## **DEVELOPMENT APPLICATION ASSESSMENT REPORT**

Application Number:	DA2025/0043		
Responsible Officer: Dean Pattalis			
Land to be developed (Address):	Lot 2264 DP 752038, 150 Allambie Road ALLAMBIE HEIGHTS NSW 2100		
Proposed Development:	Alterations and additions to a dwelling house		
Zoning:	Warringah LEP2011 - Land zoned R2 Low Density Residential		
Development Permissible:	Yes		
Existing Use Rights:	No		
Consent Authority:	Northern Beaches Council		
Land and Environment Court Action:	ı: No		
Applicant:	Rui Miguel Ribeiro Da Costa E Silva Belinda Silva		
Application Lodged:	03/02/2025		
Integrated Development:	No		
Designated Development:	No		
State Reporting Category:	Residential - Alterations and additions		
Notified:	13/02/2025 to 27/02/2025		
Advertised:	Not Advertised		
Submissions Received:	2		
Clause 4.6 Variation:	Nil		
Recommendation:	Approval

## **B3 Side Boundary Envelope**

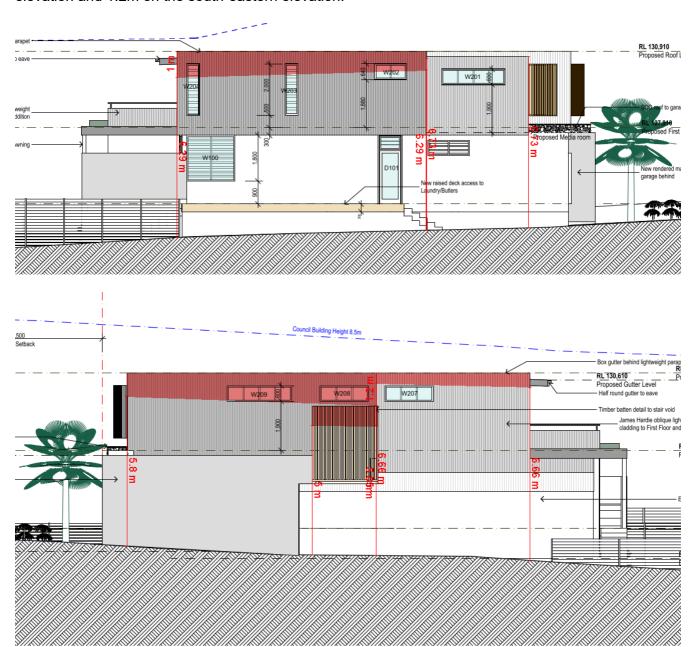
The proposed first floor encroaches the building envelope by a maximum of 1m on the north-western

elevation and 1.2m on the south-eastern elevation.

It is noted the proposed first floor provides generous side setbacks of 2.73m - 2.29m on the north-western side and 1.8m - 2.66m on the south-eastern side, as well as providing generally minised floor to ceiling heights. The proposed non-compliance is therefore considered to be result of existing on-site development and the sloping topography of the site. The proposed first floor is also suitably articulated with varied wall lines at first floor level to soften the proposed bulk and scale.

It is also noted that amended plans were submitted during the assessment process in response to a Council RFI which improved the south-eastern side setback distance to the first floor to result in an improved building envelope arrangement.
